Notice of EU RoHS Directive on Servomotor

April 2025

Servomotor

Location of the targeted load-side bracket

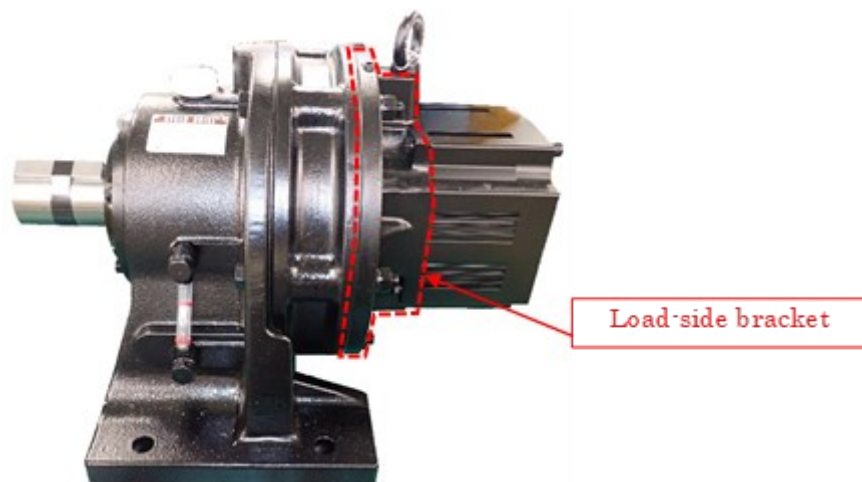
Recently, it was found that the load-side bracket used for the servo motors exceeded the permissible limit value of a certain phthalate ester (DEHP) restricted by the EU RoHS directive.

When disassembling the product at the time of disposal, use protective equipment and avoid direct contact with the primer paint.

In any case, during product use, the primer coating will not directly encounter the human body.

See below for the location of the relevant parts for product.

We have already reported this matter to the authorities in various EU countries and have been taking appropriate legal action. In addition, we are currently shipping products with appropriate components.
